Contractor:  TIANCHEN CORP. CHINA	Project :	MKP Methanol Project			Owner :  شرکت کیمیای پارس خاورمیانه Middle East Kumiya Pars Co.
	Unit	General Technical	Phase	Detail Engineering	
	Doc. Title :	PACKAGE HAZOP			
Vendor :  新鼎信息技術(上海)有限公司 Advanced Control & Information Technologies Co., Ltd.	Owner No.	MKP-11-DE-9000-SF-RPT-001B			Rev. : 0
	Contr. No.:	MKP-11-DE-9000-SA01-RPT-001B			
	Vendor No.	16E2416A			Page : 1 of 25

PACKAGE HAZOP

Node 2007

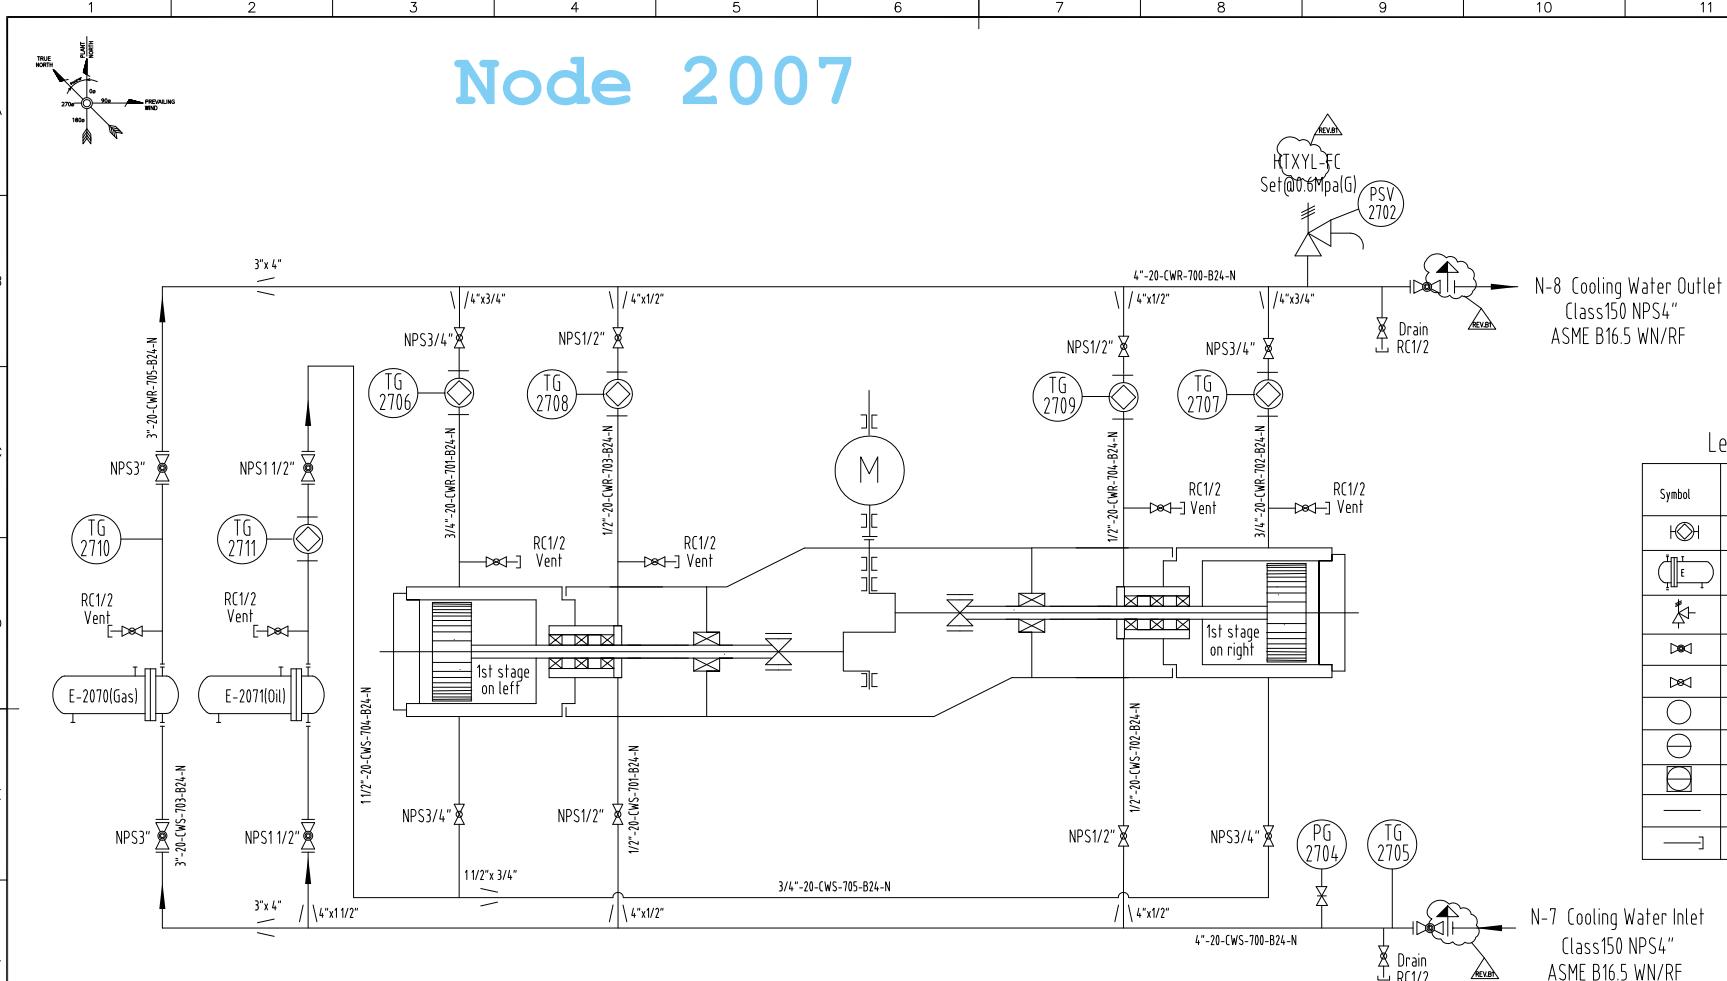
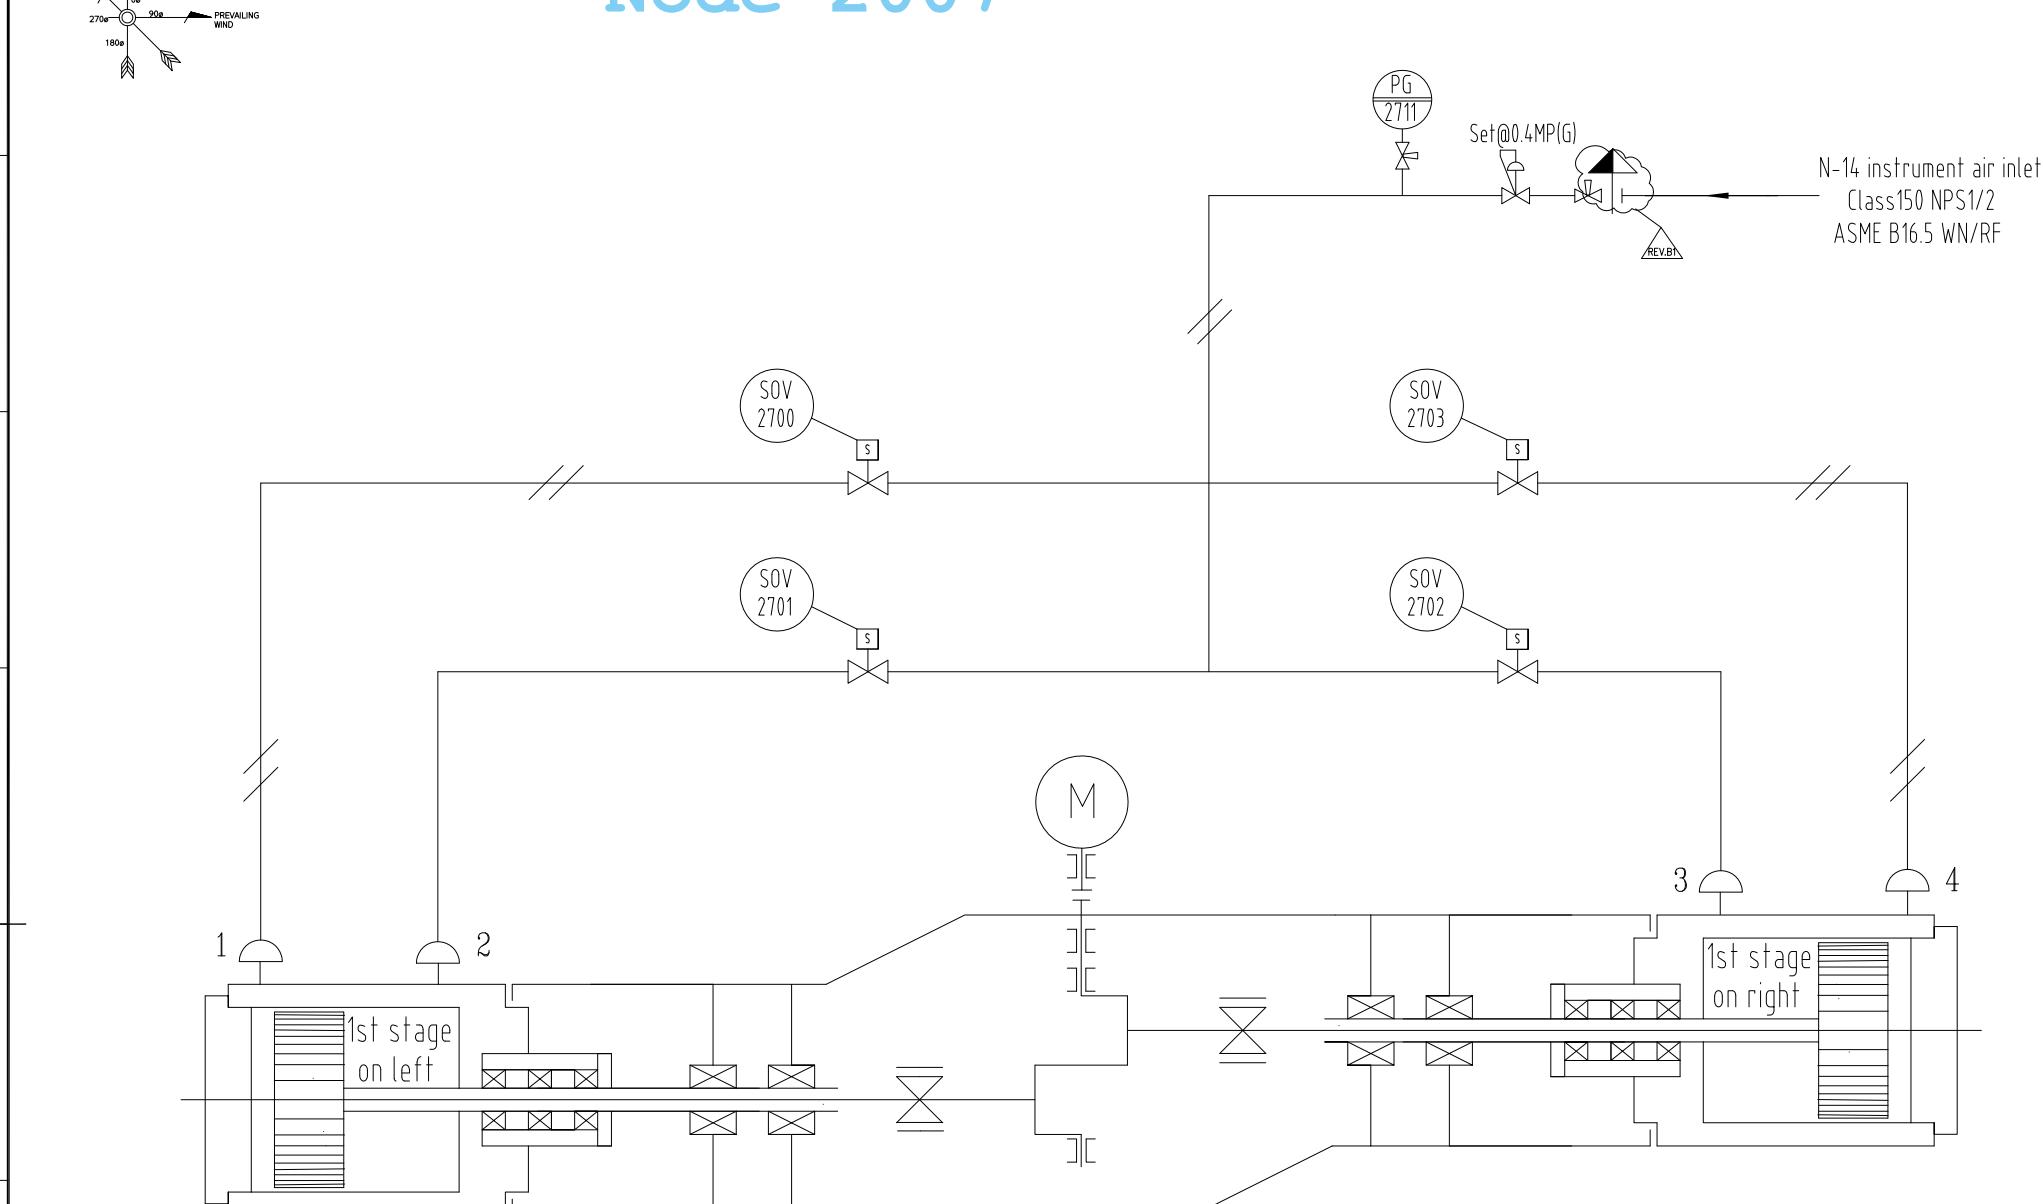
2007.3	3	1.Add the branch suction line for AOP with strainer and valve in each line. 2.Add check valve on pump P-2004B discharge.	Y			SYCC
2007.5	3	TIA-2701/2703 add high high temperature trip.	Y			SYCC
2007.9	2	PIAS-2703 add high pressure alarm.	Y			SYCC
2007.11	3	PIAS-2703 add low pressure alarm.	Y			SYCC
2007.12	3	TIA-2701/2703 add high high temperature trip.	Y			SYCC
2007.14	2	Add LST-2474A/B/C (medium of three) high high alarm and trip C-2002 by way of DCS during start-up.	Y			TCC/SYCC
2007.16	2	1.Add level switch for crank shaft tank with low trip. 2.Forbdden to start compressor when the oil level is low.	Y			SYCC
2007.17	2	PT/PI-2706/2707 add low pressure alarm.	Y			SYCC
2008.2	3	1.Revise P&ID to show alarm and interlock for temperature, pressure and flow if any. 2.Add alarm high and high high trip for TT-2579.	Y			SBW

. 4	incorrect flow direction	1 non actual hazard identify						N	
. 5	reverse flow	1 Capacity control valves (suction valves) failure.	Temperature increase, and damage piston ring,rider ring and packing ring.	1.TIA-2701/2703 high temperature alarm, and high high temperature alarm. 2.Check valve at C-2002 outlet.	3	4	3	N	TIA-2701/2703 add high high temperature trip.
. 6	part of flow/composition	1 non actual hazard identify						N

. 11	low pressure(Lube oil)	1.P-2004A/B failure. 2.Filter blockage. 3.PCV-2703 fail closed. 4.Pipe leak.	Damage crank shaft and bearings.	1.PIAS-2703 \leq 2.7 barG automatic start axuiliary oil pump, and PIAS-2703/2704/2705(2oo3) \leq 2.0 barG shut down. 2.PDIA-2702 high d/p alarm for filter blockage.	3	4	3	N	PIAS-2703 add low pressure alarm.
. 12	high temperature(Process gas outlet)	1.Cooling water supply failure. 2.Capacity control valves failure. 3.Feed gas low flow.	1.Compressing ratio increase 2.Temperature increase, and damage piston ring,rider ring and packing ring.	1.TIA-2701/2703 high temperature alarm, and high high temperature alarm at compressor outlet. 2.Process gas inlet low pressure alarm PIA-2700.	3	4	3	N	TIA-2701/2703 add high high temperature trip.
